DATE		CALIFORNIA INSTITUTE OF TECHNOLOGY MASSACHUSETTS INSTITUTE OF TECHNOLOGY		LIGO PROJECT	
DRWN	11-12-92	I-Deos CAD file: D990646-A.dwg			
CHKD		dcc file: D990646-A.pdf			
ENGR		TITLE			
APPD		POST SHIM MODIFICATION			
UNLESS OTHERWISE SPECIFIED:		SCALE: NTS			
DIMENSION UNITS ARE inch (mm)		SIZE	DRAWING NUMBER	SHEET	
TOLERANCES ARE:		B	D990646-A	1 of 1	
X.XXX: ± .005					
X.XX: ± .01					
ANGLES: ± .25°					
NEXT ASSEMBLY:

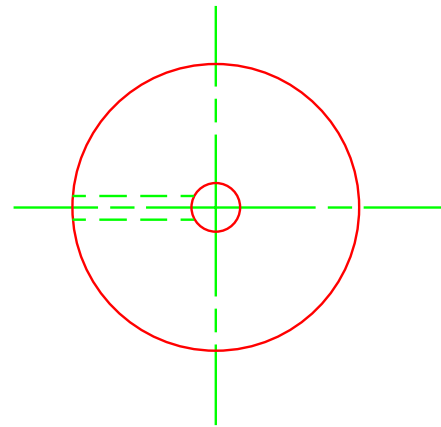
REV	DATE	DRAWN BY	CHECKED	DCC	DCN/DESCRIPTION
A	11-11-99	C. CONLEY			E990349-00-R

ADD VENT HOLE

MODIFY THORLABS P/N PS4
(1.5" DIA X 3/4 HIGH CRES SHIM)
